Access Compliance Report

Public Rights-of-Way

Intersection ID: 46324	Main Street: ARBOR_VISTA_DR	Cross Street: SENATOR_ROYALL_DR	Location: NW
ADA ID: 56F3E94FFDC6	Ramp Type: Perp	Initial Pass/Fail: Pass	Overall Compliance: No
		Severity Score: 22.5

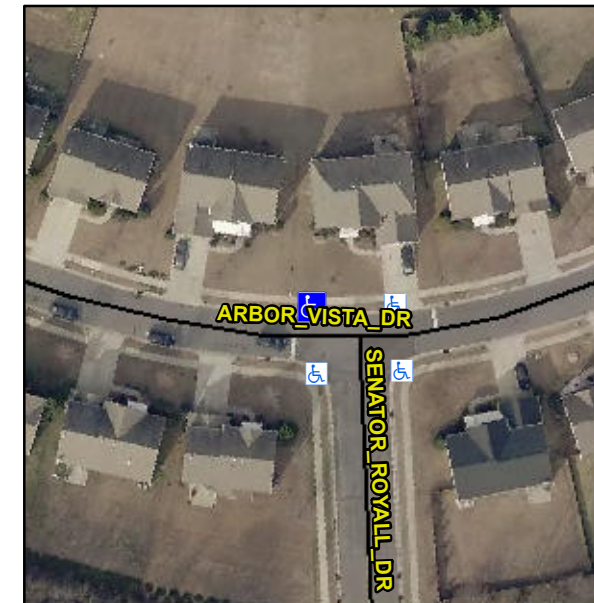
**R304.2.2-Perp, R304.3.2-Para, R305,
R302.7.2, R304.5.4**

**Remove & Replace Entire Ramp.
Remove & Replace Gutter.**
